# ICC A117.1 Comments on 1<sup>st</sup> Draft

Proposal list to the 2017 A117.1 for the 2023 edition –  
8-31-2023  
Chapter 6

## CHAPTER 6 PLUMBING ELEMENTS AND FACILITIES

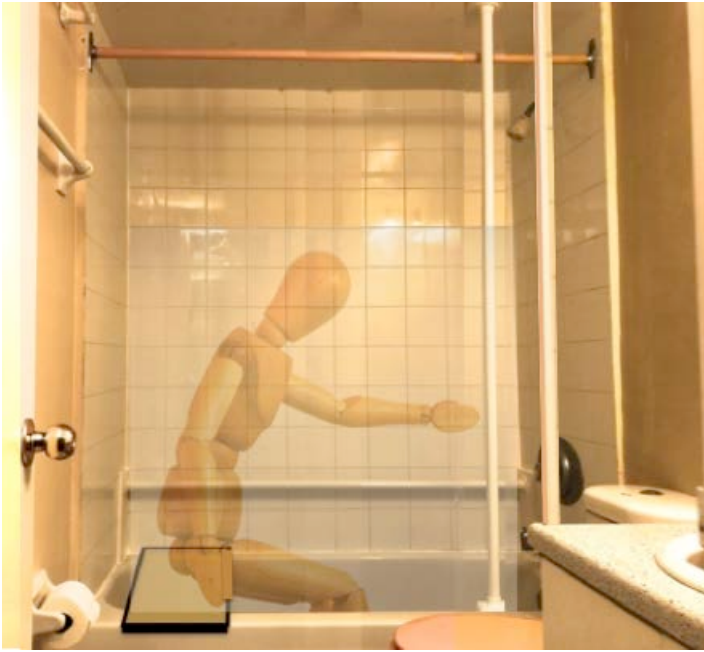
The photo at the left side demonstrates two options for a center tub-length stanchion, one affixed with RTV adhesive to a 60-year old enamel steel bathtub that has no problem with a test 330-pound, lateral load held for three hours. For newer, less rigid bathtub materials such as acrylic or fiberglass, manufacturers have raised a huge fuss over rim mounting of stanchions. They are easily appeased with the option of mounting on the adjacent floor—which is far more sturdy than the newer tubs are and has no issues with the RTV adhesive. Again, with many solid, well-performing steel bathtubs currently installed, there is much scope for both the rim- and floor-mounting options for securing stanchions in both new and existing bathrooms.

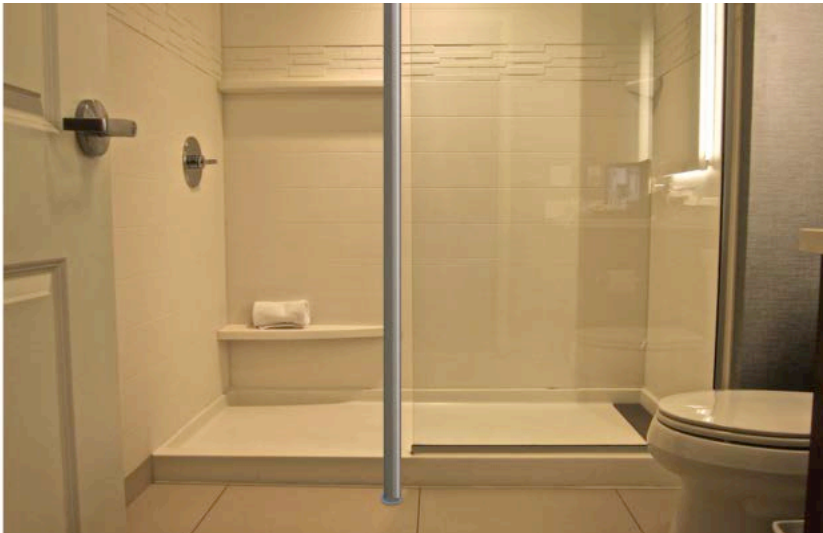
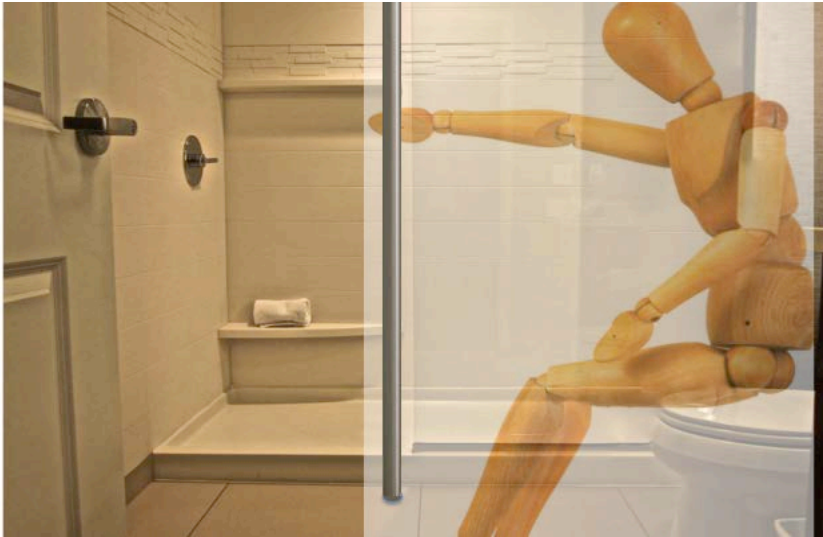
There was also some opposition—*quickly addressed*—from those concerned with the stanchion being in the way of some people with disabilities not being able to swing their fully extended legs over the tub rim when seated on a bathtub seat. Note that in the photo above, left side, there is barely room for such legs at the closely positioned WC which effectively blocks almost half the length of the tub. Notably the proposed language for A117 allows the vertical, access-side stanchion to be placed anywhere on or immediately adjacent to the entire length of the bathtub. Thus the stanchion can be placed where it suits a bather who desires to use a bathtub seat, etc.

This augmented photo illustrates the possible dilemma over such vertical stanchion placement. Is it too close to the seat; is it too far from the seat (like the water controls are), or is it just right? The proposal is open to all options on this matter (keeping in mind the value of the stanchion also serving the water closet as set out in proposed new Section 604.12 in which the performance requirement of a 28-inch reach distance is utilized.) The 28 inches is based on a reachability analysis as well as being explained and illustrated in Appendix A to this proposal). Note also a second vertical stanchion digitally added at the vanity side serving the water closet.

**FIGURE 607.3**  
**CLEARANCE FOR BATHTUBS CONTROLS**

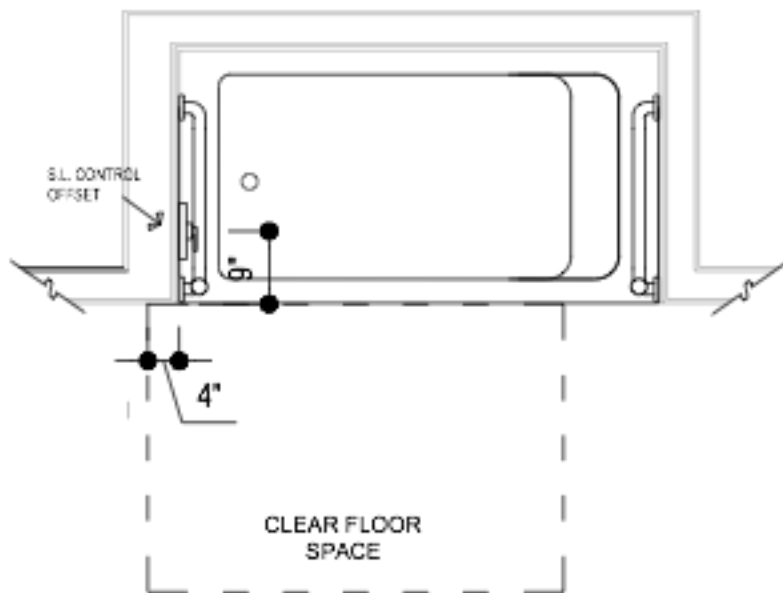
*Note: The wall in the Figures 607.2(A) and 607.2(B) would be jogged to indicate the additional 4 inch toe clearance in the new Figure 607.3. The committee will need to decide if Figures 607.2(A) and 607.2 (B) should*

be revised to show the control clearance with the transfer clearance or if the control clearance should be in a separate Figure 607.3. The figure submitted indicates the transfer clearance moving forward, not an addition 4 inch control clearance as the text indicates.

**607.3 Control Clearance.** The clear floor space for toe clearance at the controls shall extend 4 inches (100 mm) minimum beyond the control end wall.

**FIGURE 607.3**  
**CLEARANCE FOR BATHTUBS CONTROLS**

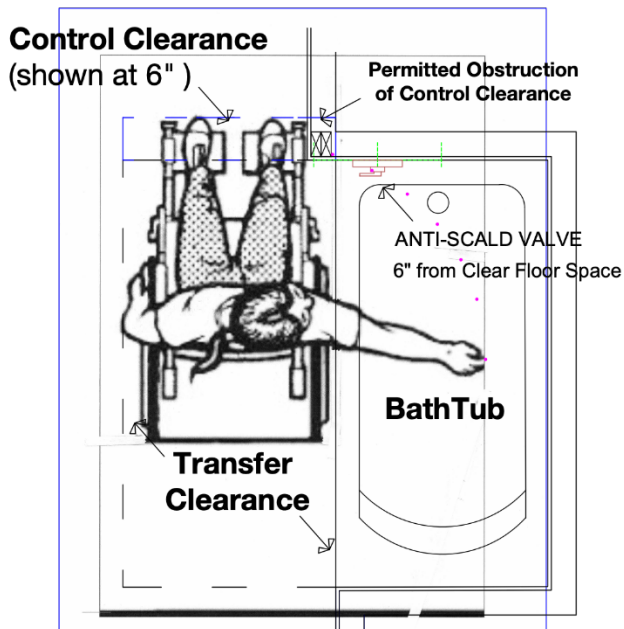
*Note: The wall in the Figures 1103.11.2.5.1(A) and 1103.11.2.5.1(B) would be jogged to indicate the additional 6-inch control clearance in the new Figure 607.3*

**607.3 Control Clearance.** The clear floor space for toe clearance complying with Section 306.2 at the controls shall extend 6 inches (152 mm) minimum beyond the control end wall. An obstruction by the control wall of 4 inches (102 mm) maximum shall be permitted.

Figure 607.4.2(A) Grab Bars for Bathtubs with Removable In-tub Seats – Elevation  
*Note – seat would have to move forward in graphic*

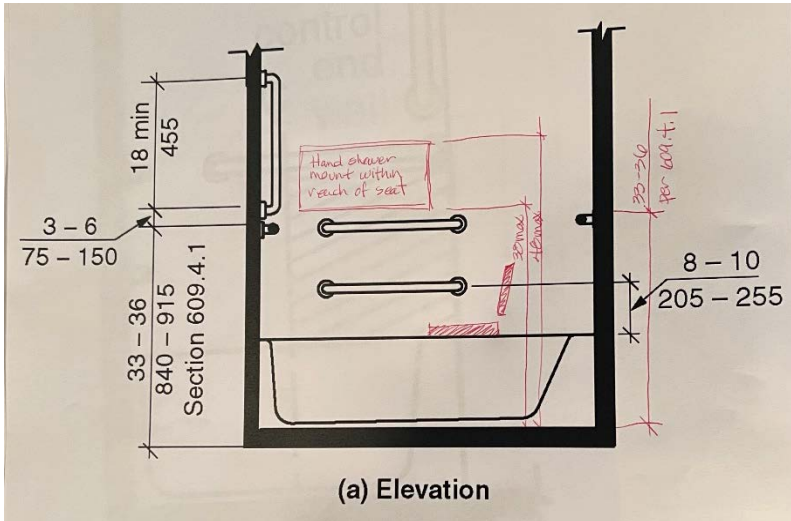
Figure 607.4.2(B) Grab Bars for Bathtubs with Removable In-tub Seats - Plan  
*Note – seat would have to move forward in graphic*

**607.4.2 Bathtubs with removable in-tub seats.** For bathtubs with removable in-tub seats, grab bars complying with Section 607.4.2 shall be provided.

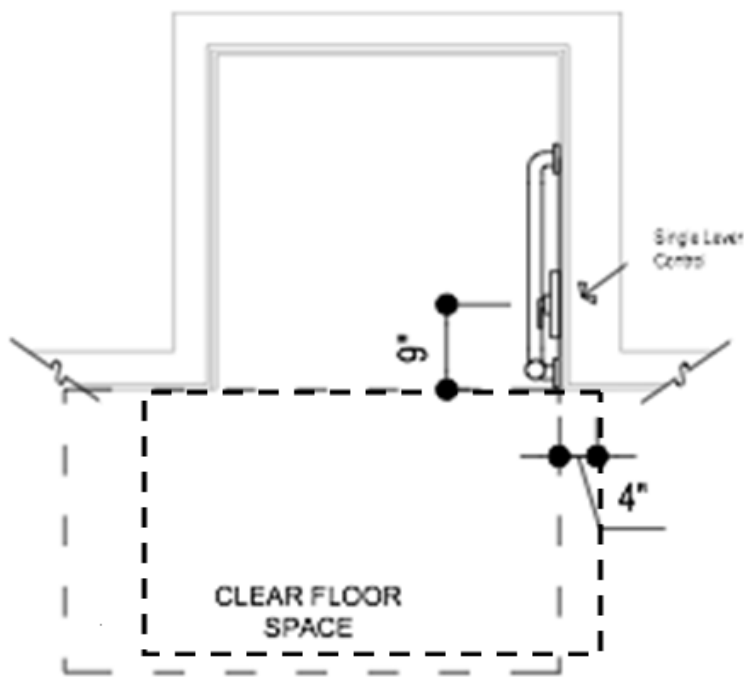
**REASON:** Based on anthropometry, the provision of toe space past the control end of the fixture accomplishes realistic reach of the control for 90% of persons measured

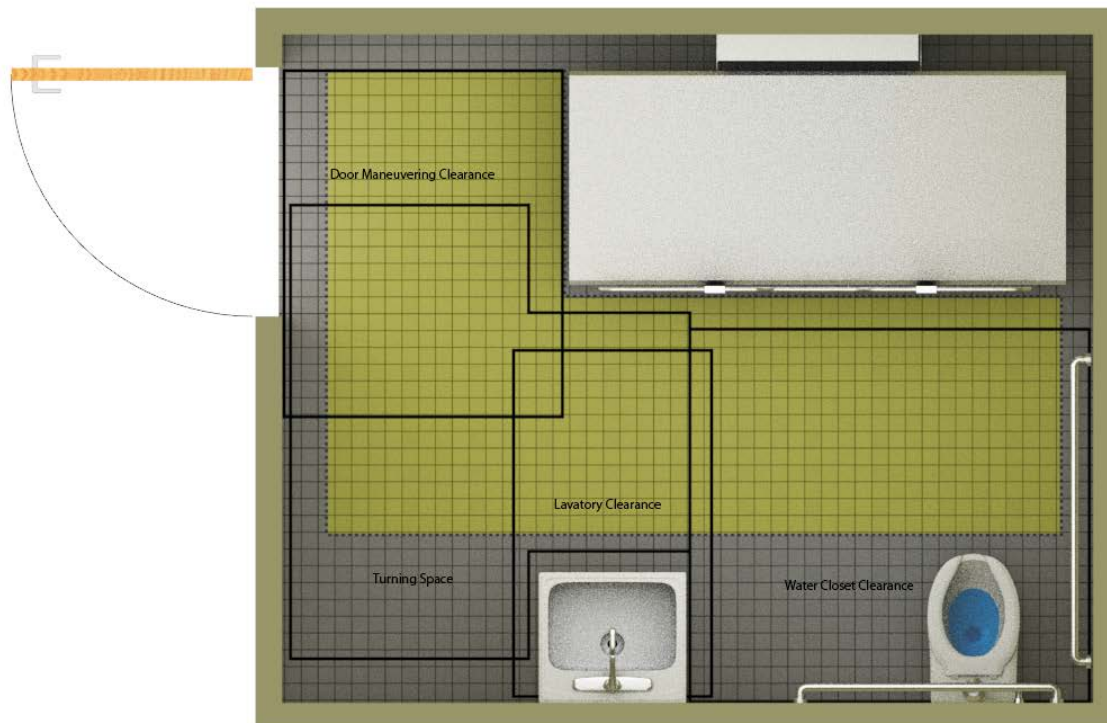
A side rail is needed on open side of changing surface to prevent person being cared for from rolling off. The 5” minimum height from the top of the side rail to the changing surface is considered a practical height for the caregiver to lean over.
